SHIRE OF DENMARK

## Special Council Meeting

**12 May 2026**

### 5.1 STRUCTURE PLAN – LOT 621 HARLEQUIN STREET AND LOT 1 SOUTH COAST HIGHWAY, DENMARK

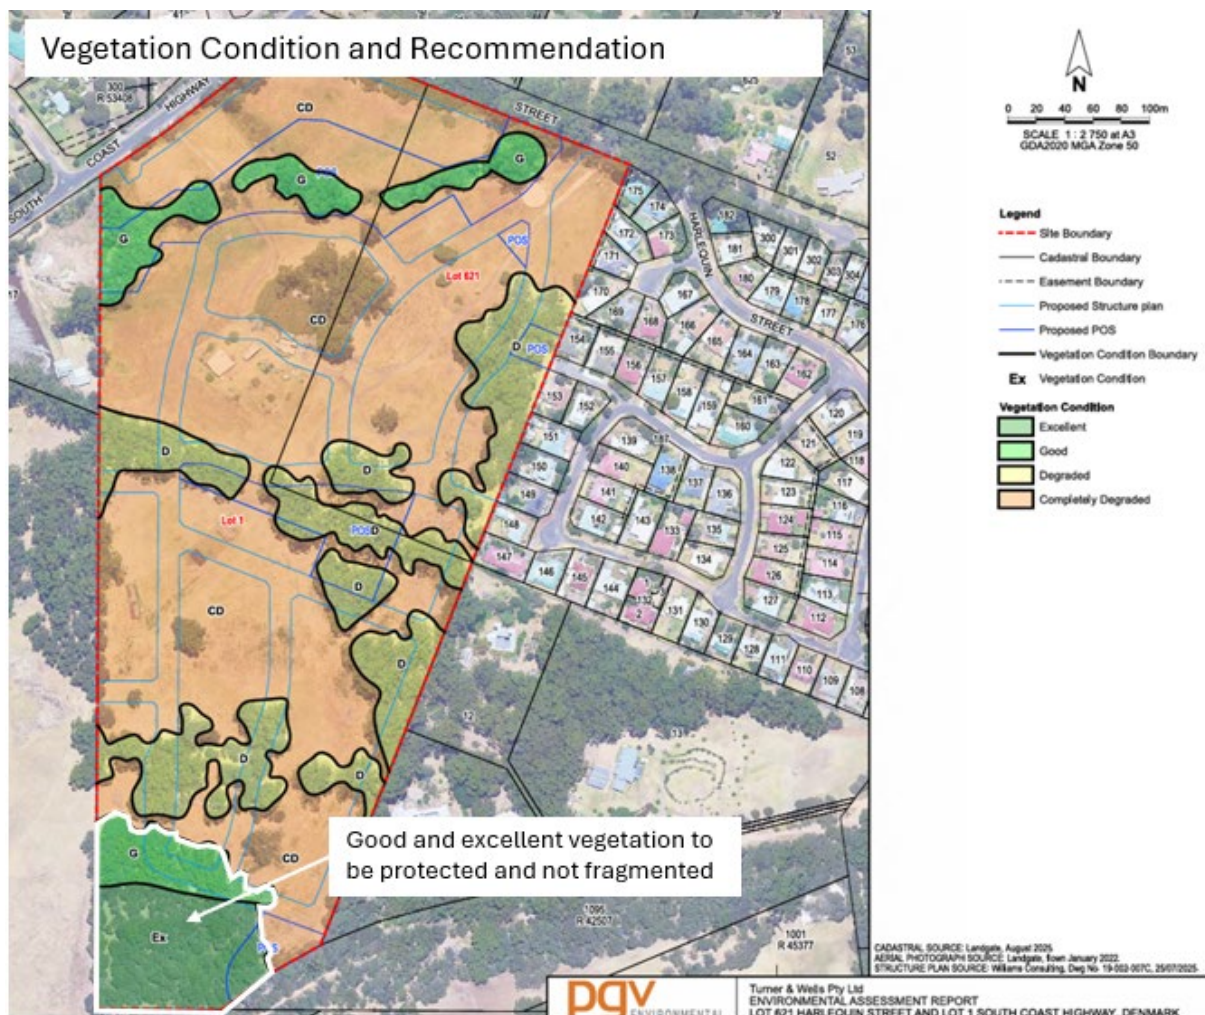
22. The identification of public open space on the ridgeline, within which the mature Karri trees of medium to high value Black Cockatoo habitat is retained and protected, is supported. The trees also contribute significant landscape, visual and amenity value and enhance the recreational function and use of public open space for future residents. The shape and function of this public open space is assessed in more detail below.
23. The protection and retention of riparian vegetation within the creek line within public open space, is also supported, consistent with best-practice environmental outcomes and waterway protection objectives. The shape and function of this public open space is assessed in more detail below.
24. In general, the protection and integration of environmental and landscape features within public open space is supported.

25. Larger lot sizes can support the retention of existing vegetation, and the use of building envelopes can help direct development away from significant trees. However, achieving meaningful tree retention on private lots requires careful subdivision-stage coordination to ensure the lot size and shape, proposed lot boundaries, mapped Tree Protection Zones and building envelopes are mutually consistent and enforceable.

26. The area to the south, identified as good to excellent condition with high fauna habitat value, is proposed to be subdivided into larger lots. This approach will result in significant fragmentation of high-quality remnant vegetation due to clearing associated with dwelling construction, asset protection zones, Bushfire Attack Level (BAL) compliance and requirements under the Shire's annual Firebreak and Property Management Notice and is not supported.

27. This outcome is contrary to EPA advice and Local Planning Scheme No. 3 provisions, which seek to retain areas of significant environmental value in a consolidated and secure manner.

28. The original recommendation tabled at the April OCM was that the Structure Plan be modified to comply with EPA's advice and LPS3 provisions, by retaining the area within public open space for conservation purposes.
29. Following further assessment and the proponents' concerns around this matter, other options have been considered. Various planning mechanisms can be applied to protect vegetation in good to excellent condition along the southern boundary of the subject land. As such, this area does not necessarily need to be secured as a POS to protect the vegetation community. It is recommended that this area be identified as a 'vegetation protection area' to be retained and protected through an appropriate planning mechanism, such as a Local Development Plan.

### **Assessment of Liveable Neighbourhoods: Public Open Space**

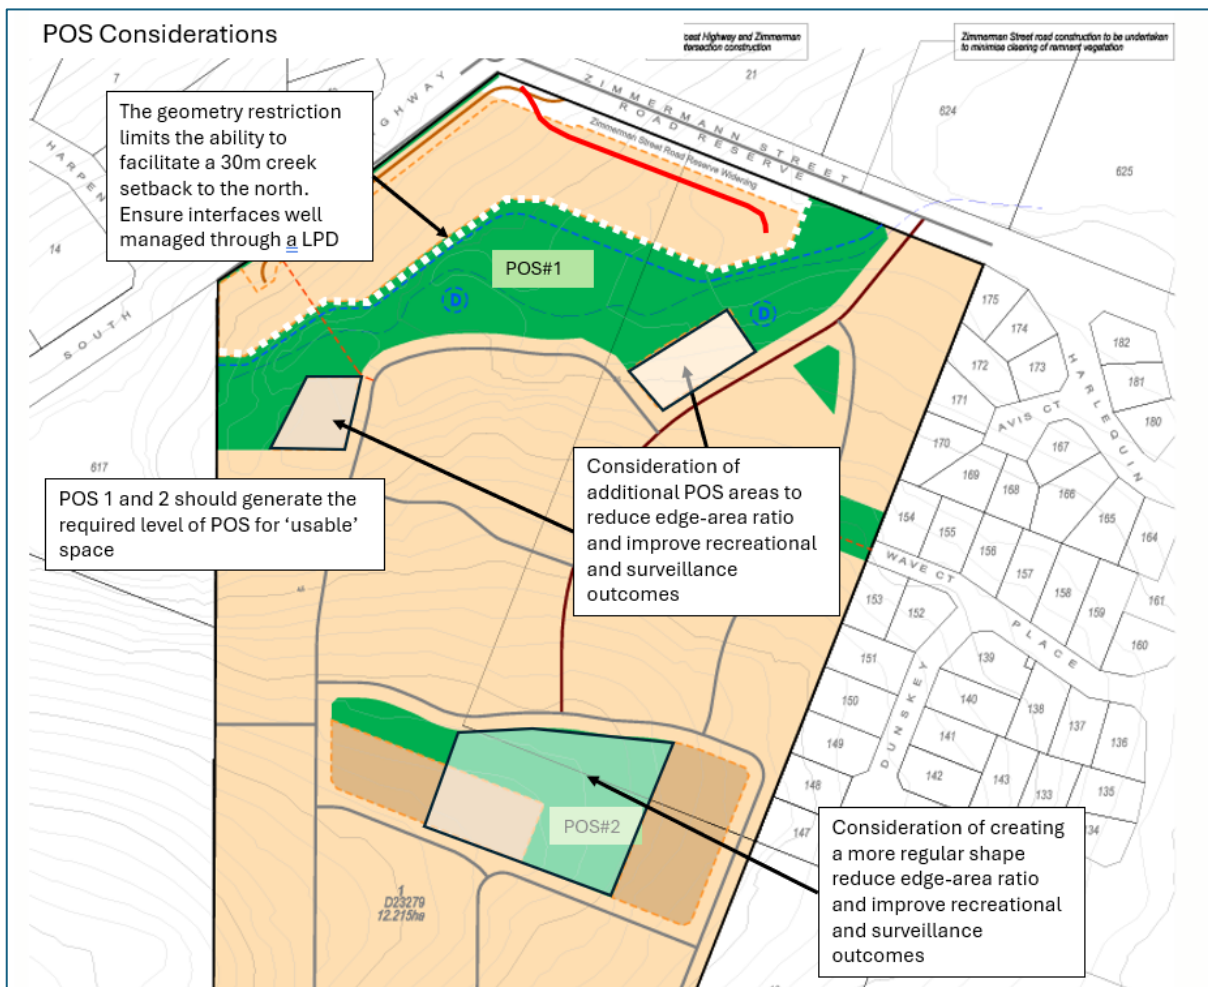
65. POS 1 (creekline POS) is irregular in shape, narrows in several locations and is proposed to accommodate stormwater functions, including detention/swale infrastructure. In the context of the limited creekline setback, foreshore reserve management requirements and the close proximity of residential lots to the waterway, the design outcome indicates that POS 1 has been configured primarily to meet minimum riparian and drainage requirements, with limited consideration of broader POS design objectives and community usability.

66. The extent to which drainage infrastructure (including detention basins/sumps) will reduce the area of usable parkland in POS 1, is not clearly demonstrated at the Structure Plan stage. This creates a reasonable perception that POS is being treated as secondary to drainage infrastructure, rather than being planned as a valued public place. While integrating stormwater management within POS can be supported where appropriately designed, this is only acceptable where recreational value, accessibility and safety are clearly retained and the drainage function does not dominate the public space.

67. POS 2 appears to have been primarily shaped around retention of vegetation, rather than being configured to deliver a coherent and functional recreation space.

68. Both POS 1 and POS 2 have a number of lots that front and actively address the open space, with many lots instead backing onto or side-addressing the POS. Combined with the irregular configuration, this produces a high edge-to-area ratio, meaning there is a disproportionate amount of boundary (often fencing interfaces) relative to the amount of usable POS. This weakens casual surveillance, reduces perceived safety and diminishes the everyday relationship between residents and the POS.

70. POS 3 (Wave Court) appears to function primarily as an emergency accessway, while POS 5 is identified primarily for drainage infrastructure. In principle, there is no objection to small, purpose-specific pockets of POS, provided the broader POS network delivers high-quality, usable public space outcomes. In this case, POS 1 and POS 2 which comprise the main public open spaces, have not demonstrated that they achieve strong recreation, usability and surveillance outcomes, which reduces the acceptability of relying on additional POS areas that are largely functional in nature. POS 4 is effectively residual land and does not appear to provide a meaningful recreation or community function and is not supported.

- c) Review the provision of public open spaces that demonstrably meet the design objectives of both the Shire's Local Planning Policy 39: Public Open Space and Liveable Neighbourhoods having regard for function, shape and edge treatment, including consideration of the requirements under WAPC's State Planning Policy 2.9: Water to protect the creek and its biophysical values.

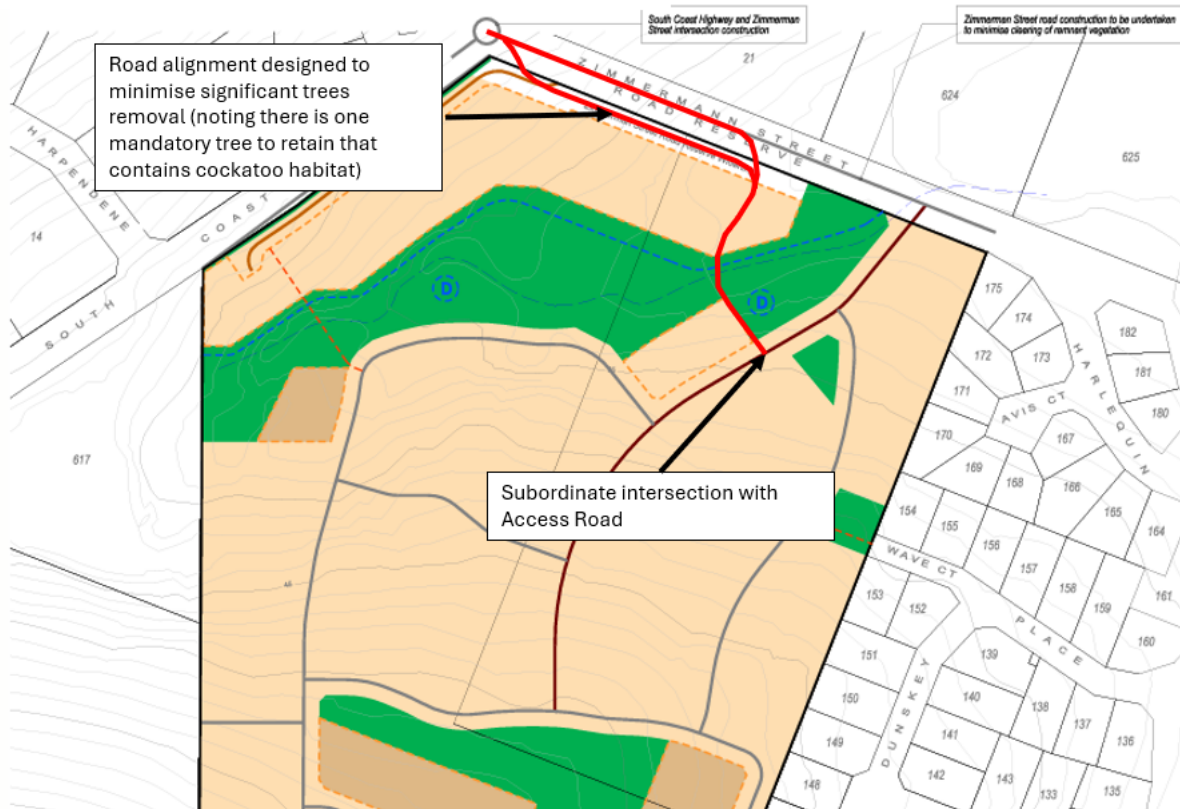
88. The applicant seeks to retain access to the subject land via the Zimmerman Street road reserve. The rationale for this appears to be:

- That the road reserve width and topography at the previously recommended site at a mid-point between Ross Court and Harpendene Rise would not facilitate a passing bulge resulting in a difficult and expensive intersection.
- The Zimmerman Street alignment would make a more attractive entry to the future subdivision in either a boulevard approach with retained trees through the centre aisle or the road along the western edge of the existing vegetation.

89. Main Roads originally objected to the access road alignment in the advertised structure plan due to the creation of a through road/shortcut to Ocean Beach Road, increasing traffic impacts on South Coast Highway, the Kemsley Estate community and Ocean Beach Road.

90. It is accepted that shifting the access road to the mid-point between Ross Court and Harpendene Rise is not the only way of addressing the concerns raised during

advertising and assessment of the structure plan. Having regard to the objection from Main Roads regarding through traffic concerns, and the identified environmental constraints associated with constructing a creek crossing within the road reserve, an alternative access arrangement is recommended.

- d) Relocate the proposed road within the Zimmerman Street road reserve to align with the western boundary of the road reserve at South Coast Highway, then cross the creekline at a location outside the Zimmerman Street road reserve that minimises environmental impact and connect to the internal road network, within the structure plan area, in a manner that establish a subordinate right of way.
